Regarding examiner’s objection to the specification and rejection of Claim 18 as failing to provide adequate support for how the valve functions, applicant respectfully disagrees with examiner’s contention. The specification, specifically pages 8-11, contains sufficient information regarding the subject matter of the claims as to enable one skilled in the pertinent art to make and use the portable, multipurpose, air dispensing apparatus.

Figure 11

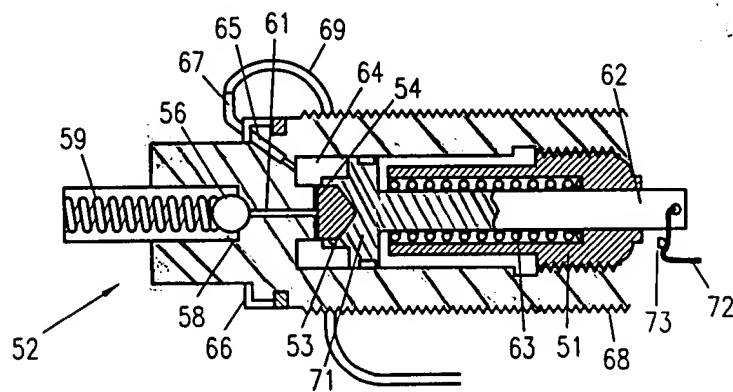
Examiner further argues that the disclosure fails to provide adequate support as to how the hard metal seat prevents a sealing seat from being achieved, and that the valve arm, threaded shank, seat, ball and spring, and associated elements are floating in the valve housing.

lines 7-8 of the specification, the ball 56, as illustrated in FIG. 11, is shown to be a spherical body and as such, upon engagement with a *hard* surface creates a tangent or a meeting of a curved surface in a single point, thereby preventing “sealable engagement” between the two, or more specifically between the ball 56 and seat 58.

Regarding the appearance that the valve arm, threaded shank, seat, ball and spring in FIG. 11 are floating in the valve housing, FIG. 11 has been amended so as to properly include hatching which was previously unintentionally omitted, thus effectively providing structural support for such elements within the valve housing and in conjunction with the specification provides further support that (“...one reasonably skilled in the art could make or use the invention from the disclosures in the patent coupled with information known in the art without undue experimentation.”). *In re Buchner*, 929 F.2d 660, 661, 18 USPQ2d 1331, 1332 (Fed. Cir. 1991).
